PLANNING REPORT

Architectural Review Board

91 S. HIGH STREET 23-055MPR

Address	91 S. High Street
Proposal	Remodel an existing, one-story building on a 0.18-acre site zoned Historic District, Historic South. The site is located northwest of the intersection of S. High Street with Pinneyhill Lane.
Request	Request approval of a Minor Project Review.
Zoning	HD-HS, Historic South District
Planning Recommendation	<u>Approval of Minor Project Review with conditions</u>
Next Steps	Upon review and approval of Minor Project Review (MPR), by the Architectural Review Board (ARB), the applicant may file for building permits through Building Standards.
Applicant	Kevin Parzych, Gunzelman architecture + interiors, LLC
Case Manager	Sarah Tresouthick Holt, AICP, ASLA, Senior Planner (614) 410-4662 sholt@dublin.oh.us

East and South views

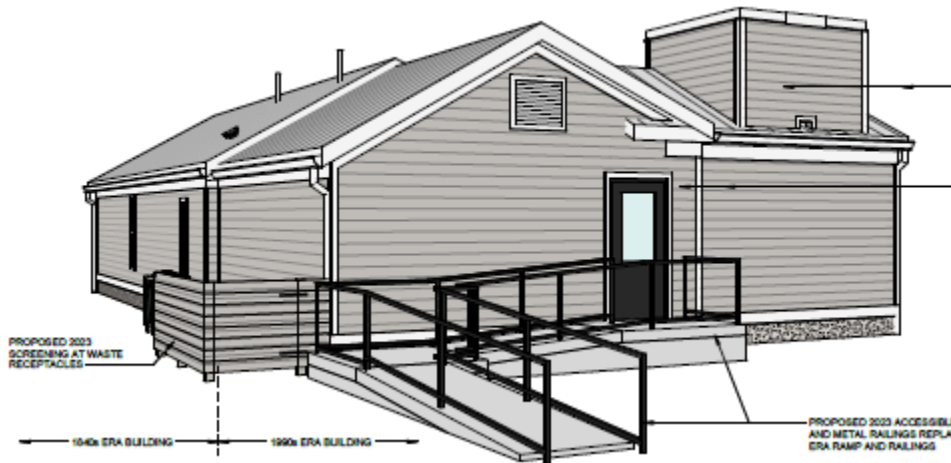
The historic front elevation is largely unchanged. The existing gable vent is proposed to be replaced with a modern one of the same size. A sign will eventually be proposed on this elevation; however, the applicant is not requesting review and approval now.

This elevation contains the front entrance to the original building, along with the 1990s ell addition. The new roof top exhaust screen is visible on the southwest corner. This is added directly to the 1990s addition and does not impact the original structure. The roof peak of the original structure is shown at 14 feet, 4 inches, and this screen sits above both the original building and the addition, at 17 feet, 7 inches, and does hide the entire exhaust as required in Section 153.173(I)(5)(a). Access to the exhaust hood will be via temporary ladder, and a swinging door is built into the screen wall, seen on the west elevation. Planning, Building Standards, and the applicant worked together to minimize the impact of this screening, and the result is appropriate.

An additional restroom exhaust cap is seen on the roof; otherwise, all siding, windows, hand railing, lighting, and other materials remain as existing.
